MODIFICATION REQUEST:

***Discovery Point Concept Plan 2011 for a Mixed
Use Residential Development
(MP10_0003 MOD 4)***

Discovery Point, 1 Princes Highway, Wolli Creek

Secretary's Environmental Assessment Report
Section 75W of the
Environmental Planning and Assessment Act 1979

Figure 5: Approved building envelopes for Buildings 11, 12, and 13 with remaining allowable GFA (red shaded area shows a possible response to the maximum GFA deleting Building 12 and reducing Building 11 by one storey).

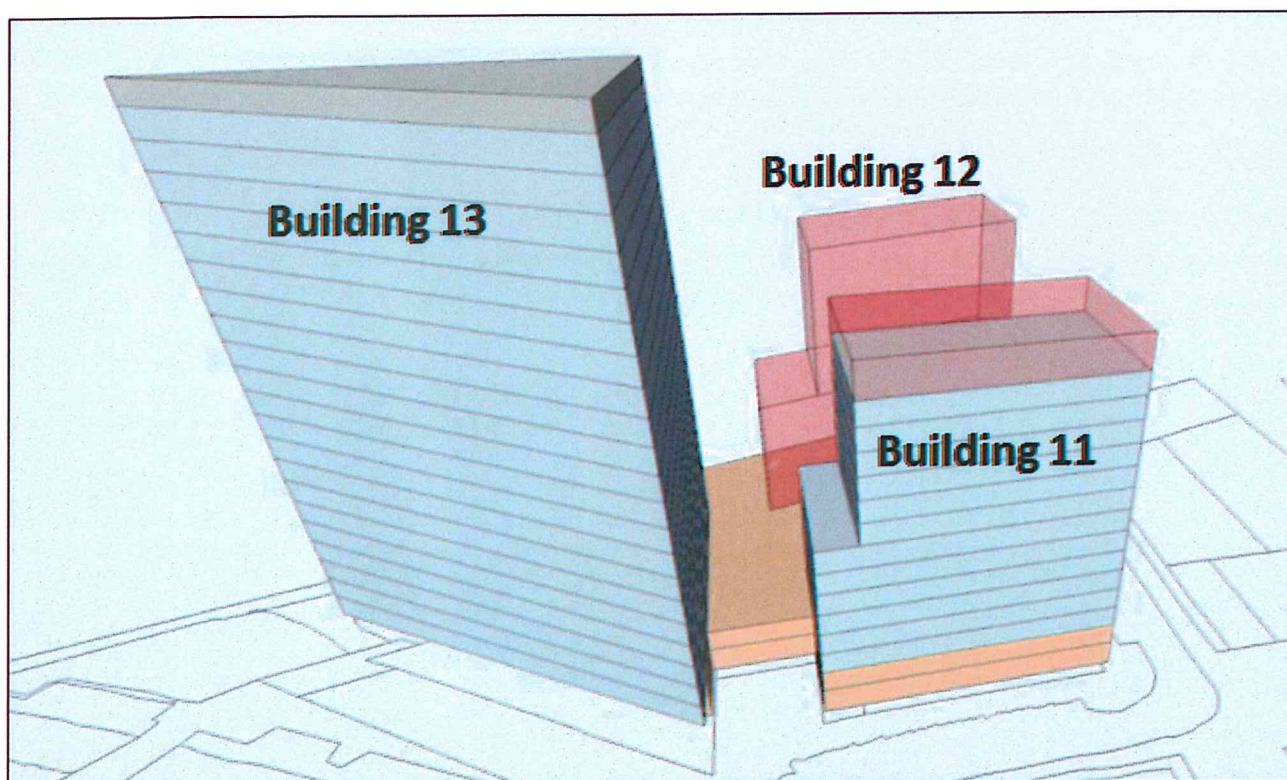
Council objects to the proposed additional 10,685m² of GFA and contends that an increase in GFA will limit opportunities for quality building design and residential amenity within the approved building envelopes.

The Department's original assessment considered that the site is able to support higher residential densities due to its access to Wolli Creek Railway Station and Princes Highway. The Department maintains its view that the site is strategically well suited to increased densities as it is consistent with the current metropolitan strategy, *A Plan for Growing Sydney*, which encourages growth in housing supply (setting a target of 644,000 additional dwellings for the Sydney region), particularly in well-served locations. In particular, the site is ideally located for increased residential densities contributing to the housing target, given its location within eight kilometres of the CBD, excellent access to public transport being immediately adjacent to the Wolli Creek Railway Station, access to convenient retail services, and accessibility to existing infrastructure including parks and the Cooks River green space network.

The Department considers that the proposed increase in density is acceptable for the following reasons:

- the proposed additional floor space would be contained within existing approved building envelopes which have already been determined as being acceptable in terms of urban design and amenity;

Figure 8: Proposed treatment of above ground car parking for Buildings 11-13.

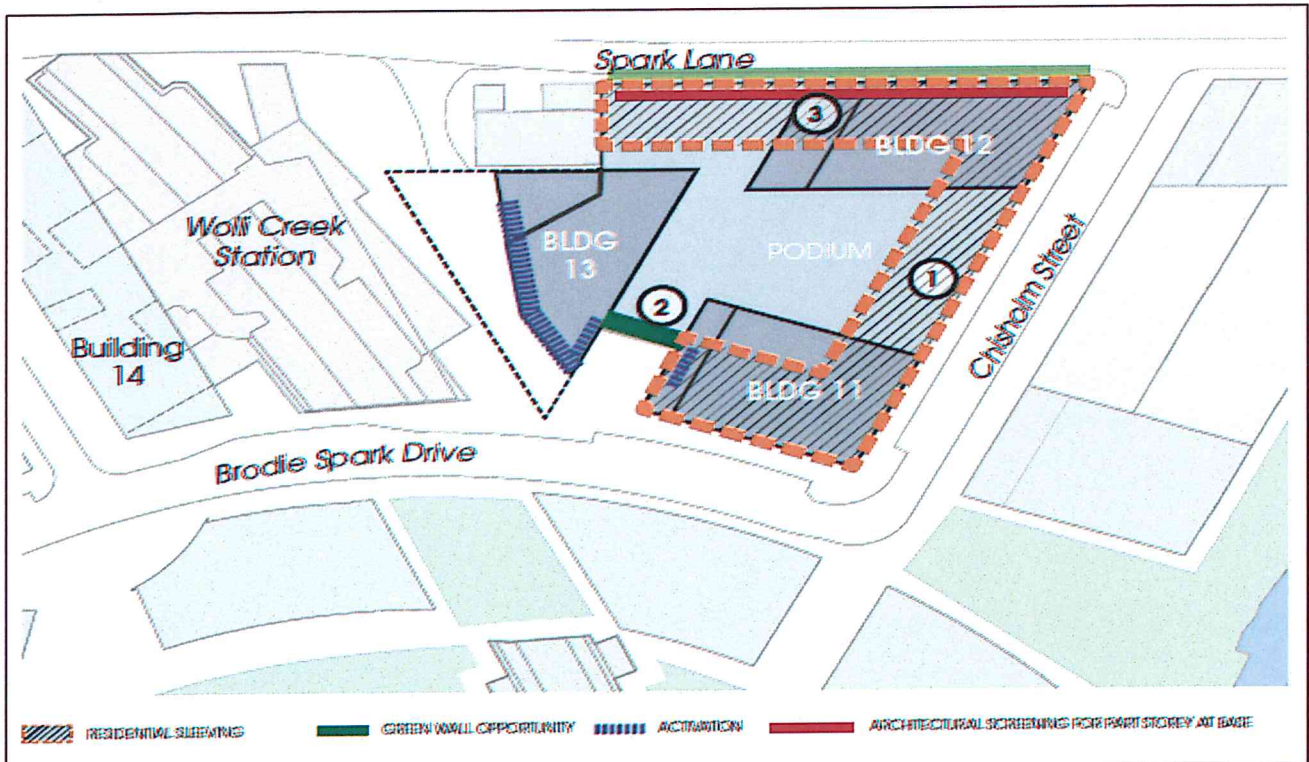
Council considers that the two levels of additional above ground car parking proposed should be appropriately screened and articulated to mitigate any visual impacts.

The existing Concept Approval includes a Future Environmental Assessment Requirement to ensure that the above ground car parking is not visible from the streetscape. Additionally this is consistent with the approved Design Guidelines and is a design treatment that has been approved elsewhere on the site. The Department considers it to be an acceptable design outcome.

Figure 11: Plan showing open spaces, communal facilities and community facilities provided via Concept Approval.

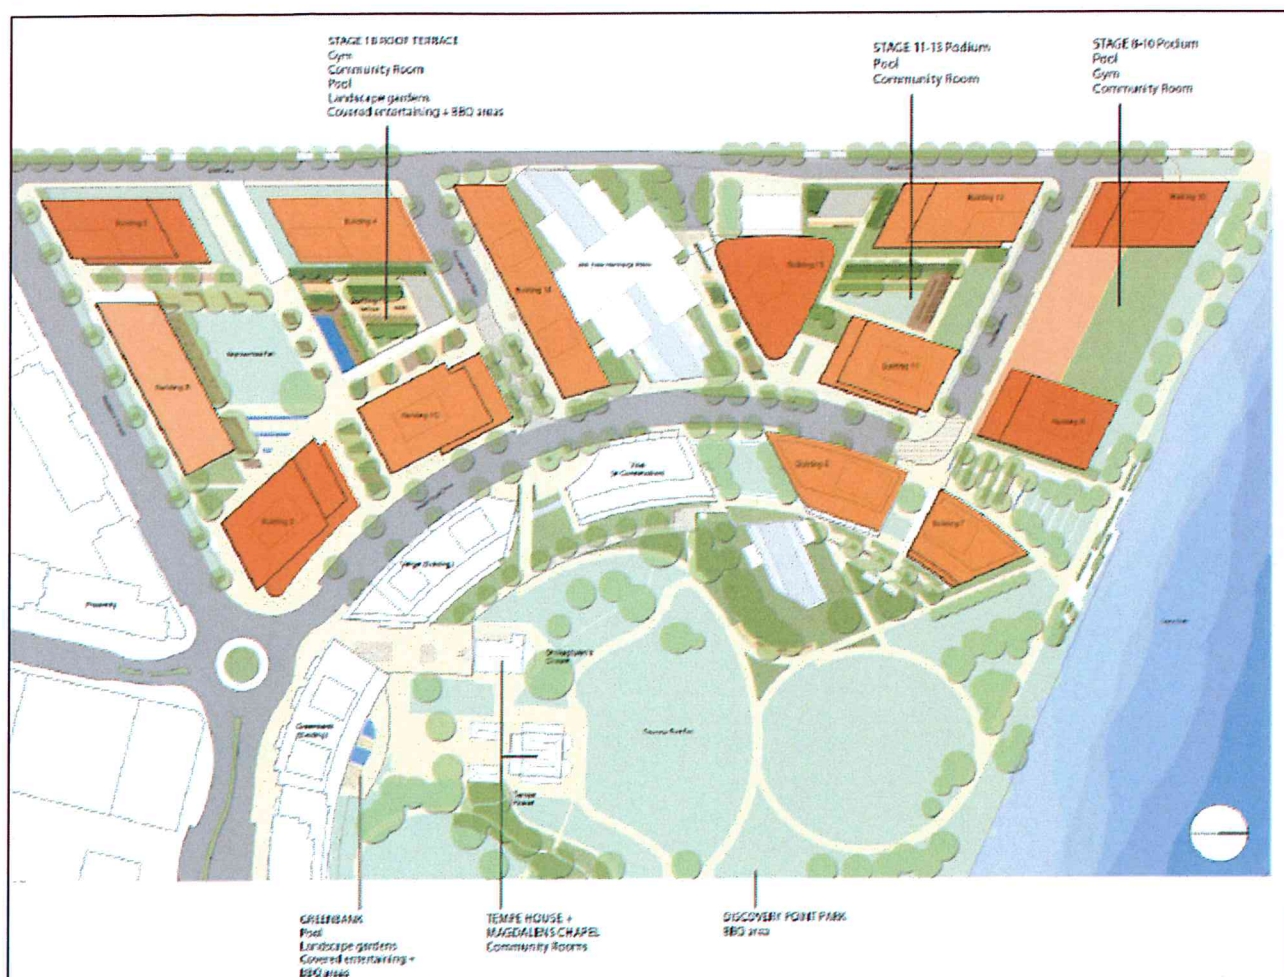
Council has raised concern that no additional public benefits are proposed despite the uptake in development yield. Council considers that the proposal should only be supported if additional public benefits are proposed. Council is willing to engage in discussions with the Proponent on a Voluntary Planning Agreement for public benefits identified within Council's Section 94 Contributions Plan which may include a new multi-purpose community facility within Discovery Point and/or pedestrian and cycle ways facilities connecting the regional recreation network.

The Department has reviewed Council's request for additional public benefits in the context of Council's Section 94 Contributions Plan and the proportion of contributions for facilities and services to development in Wolli Creek and the Rockdale LGA more broadly. The Department found that:

- \$4.9 million in value of physical works towards paths and cycle ways;
- a network of communal facilities and spaces including the St Magdalenes Chapel, Tempe House, and private residential communal rooms within Buildings. The proposal further seeks to provide an additional communal room and bbq facilities for future residents in the podium of Buildings 11-13 (**Figure 11**); and
- 3.08ha of open space which is located primarily on the foreshore of the Cooks River, in addition to the water based usable open space available on Cooks River and wider network of open spaces available along the Cooks River foreshore beyond the Discovery Point site (**Figure 11**).

The Department is satisfied that that the increase in population will generate a minimal additional demand for community facilities, pedestrian and cycle facilities, and open space and the contribution towards the community facility and pedestrian cycle facilities is acceptable noting:
